Project	IEEE 802.16 Broadband Wireless Access Working Group < http://ieee802.org/16 >	
Title	Network entry procedure for transparent relay station	
Date Submitted	2007-01-08	
Source(s)	Mike Hart, Yuefeng Zhou, Sunil Vadgama Fujitsu Laboratories of Europe Ltd. Hayes Park Central Hayes, Middx, UB4 8FE, UK	Voice: +44 20 8606 4523 Fax: +44 20 8606 4539 mike.hart@uk.fujitsu.com
Re:	Call for technical proposals 802.16j-06/034	
Abstract	This contribution provides a technical proposal for the RS network entry procedure for the case of a non-transparent RS. It is based on reusing many of the stages executed in the SS network entry procedure with the only major change being the introduction of new SBC and REG TLV values to enable exchange of information about PHY & MAC features supported by the RS.	
Purpose	For discussion and approval of inclusion of the proposed text into the P802.16j baseline document.

Network entry procedure for transparent RS

Figure 2. RS network entry procedure.

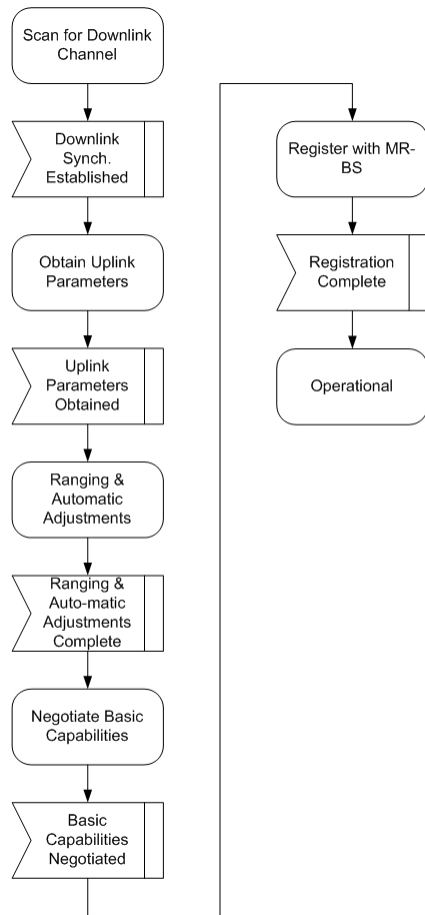
The next step where there is some modification is in the REG stage. In this case, similar to that explained for the SBC stage, new TLVs may be signaled [6] and it is proposed that the secondary management connection is not created to the RS.

The procedure for initialization of an RS shall be as shown in Figure 55. For the RS the stages e), g), h), i) and j) are not required, for all other stages the RS shall behave in the same manner as an SS during network entry unless otherwise specified in the subclauses of 6.3.9. The more detailed finite state machine representations of the individual sections (including error paths) and the timeout values shall be the same as those provided for the SS, unless otherwise specified.
